MERCURISER SERVICE BULLETIN

Number: 70-16-12

Date : 8/14/70

- A. MerCruiser 215 Power Steering (For Section X)
- B. MerCruiser Power Trim Reverse Lock Valve Leakage (Sec. X)
- C. MerCruiser 140 Timing Gears (For Section VIII)
- D. Defective Water Temperature Senders (Section X)
- E. MerCruiser 215 Gimbal Housing Leakage (Section IX)

Figure 1. Exhaust Tube Location

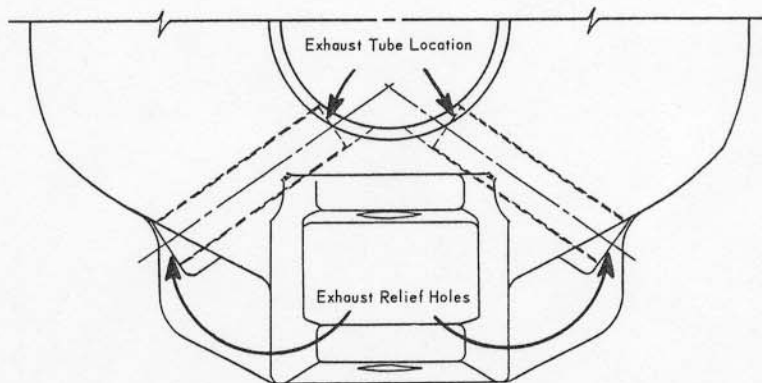
Some gimbal housings have been found leaking thru the casting near the exhaust relief holes (located on bottom of housing near the exhaust elbows). To correct this problem, coat the sides of each hole with sealer (C-92-52238-1) and insert one tube (C-32-59563A1) into each exhaust relief hole as shown in Figure 1.
